Amendment to the Drawings:

SILICON VALLEY
PATENT GROUP LLP

REMARKS/ARGUMENTS

Fig. 1

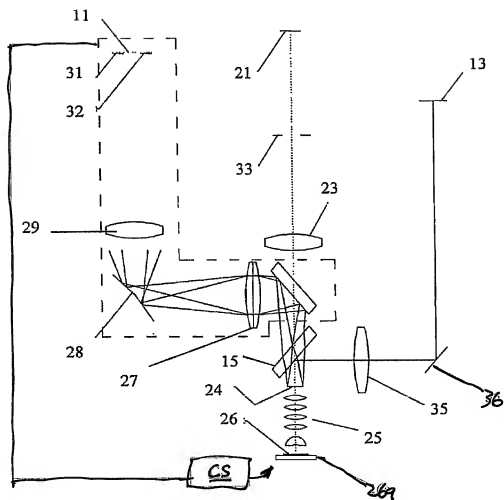
The attached sheet of drawings includes changes to Fig. 1. In Fig. 1, previously omitted reference number 36, and object 26a and control system CS have been added.

The drawings are amended to show the object 26a and a control system CS to adjust the separation between the object and the object lens and to include previously omitted reference number 36. Support for the amendment to the drawings may be found, e.g., at paragraphs [0039], [0045] and [0049]. Thus, no new matter is added.
